Item No. 5 **Amendment to Development Agreement AG 51/05 - Sage Creek File DASZ 32/2007**

Re: **Requested amendment to Development Agreement AG 51/05 (Sage Creek)**
Qualico Developments (Winnipeg) Ltd.

Re: Qualico® - Sage Creek Subdivision – Tansi Lane

FIG "A"

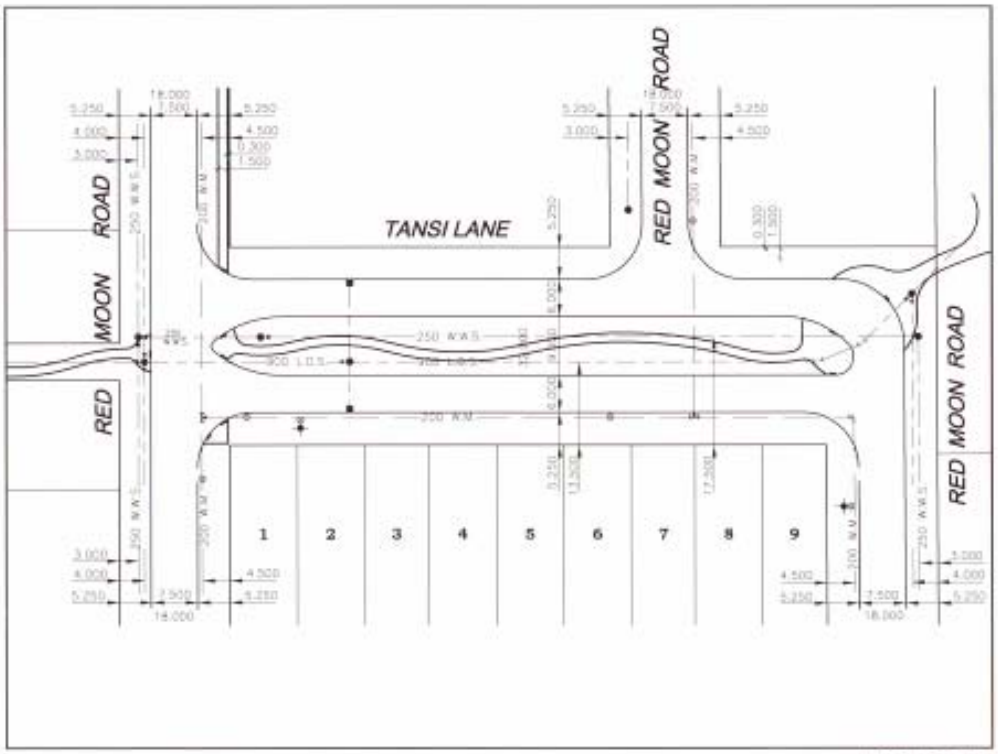
An issue has arisen regarding a request from Public Works to construct a public sidewalk on both sides of Tansi Lane which connects the north and south legs of Red Moon Road. Refer to Figure "A" attached.

At a significant cost to the Developer, Tansi Lane was constructed as a twin 6.0m pavement residential street with a wide median separating the two lanes to provide an "open" feel to the street with a central landscaped focal point, and at the same time contribute to the uniqueness of the neighbourhood. The Developer has a strong concern that public sidewalks would have a negative affect on the character of this street, given the 101' building setback. Refer to Figure "B".

- Reduced maintenance requirements for the City,
- Increased snow storage,
- A public walkway has been provided in the center median which connects with the developments pathway and park system,
- Four party utility servicing is installed on the 1.5m alignment on both sides.

In conclusion, we feel that the Developer has already exceeded the requirements of the City Standards for this street without these additional public sidewalks, and that requiring them simply because there is divided pavement and a larger than normal residential street right-of-way, is not reason enough to compromise the character of the street.

It is recommended that Development Agreement AG 51/05 be amended by adding the following to the last sentence of Clause 11. of Schedule "B"

". . . except in Tansi Lane".

The Public Works Department has no objection to deleting the requirement for 1.5m by 100mm sidewalks on both sides of Tansi Lane in consideration that the centre median pathway satisfies the sidewalk requirements at this location.
